SUNDRY NOTICES AND REPORTS ON WELLS

Merrion Oil & Gas Corporation

Hut No. 1

Merrion hereby requests your approval to modify our Application for Permit to Drill (APD) dated November 12, 1997 for the subject well as follows:

Proposed Wellbore Configuration

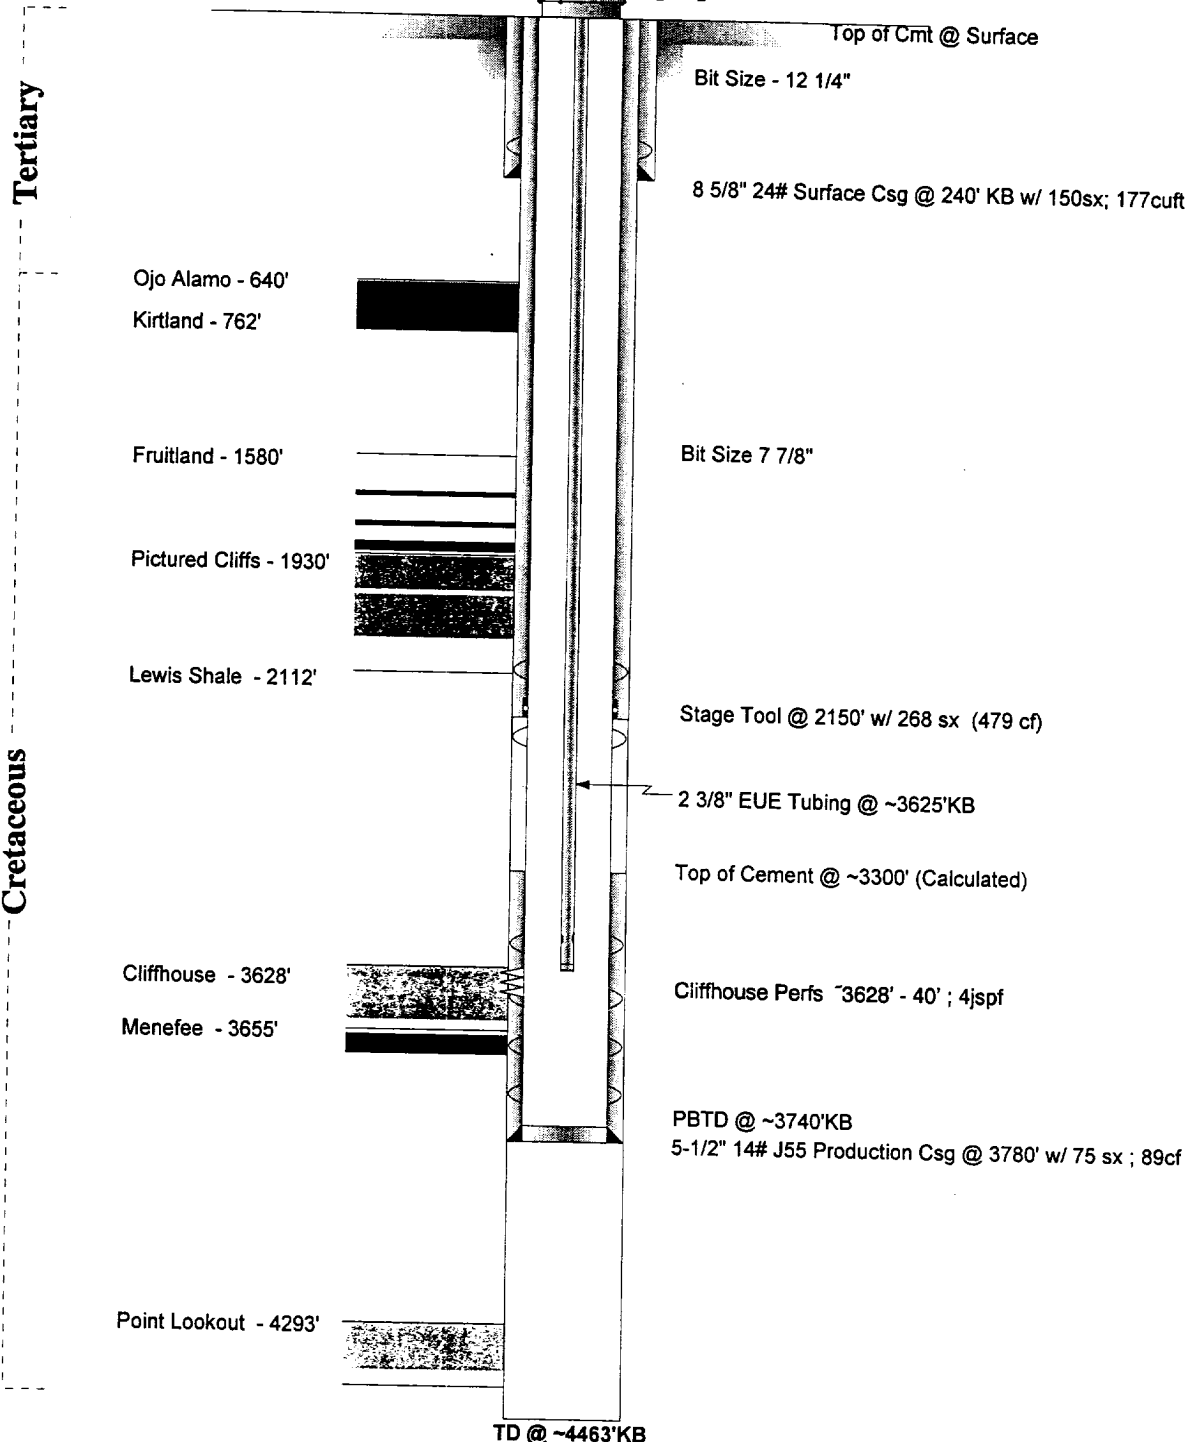
1. Propose to increase the Total Depth from 3780' to 4463' in order to drill through and evaluate the Point Lookout formation (estimated Pt. Lookout top @ 4293') . Well will TD in the top of the Mancos shale.

2. Propose to set 5-1/2" 14ppf J55 production casing thru Cliffhouse pay zone instead of 4-1/2" casing. Planned setting depth ~3780' as originally planned. Will leave Menefee and Pt. Lookout in uncemented open hole for potential use as produced water injection well from Cliffhouse. Hole sizes will remain the same.

3. Propose to modify cement volumes to cement first stage with 75 sx 'B' Neat cement (177 cuft); cement second stage with 25 sx 'B' Neat cement (30 cuft) followed by 185 sx 'B' 2% SMS (381 cuft), tail in w/ 58 sx 'B' Neat cement (68 cuft). Top of cement at surface. Will adjust volumes at time of setting casing based upon open hole caliper log.

4. A revised wellbore schematic is attached.
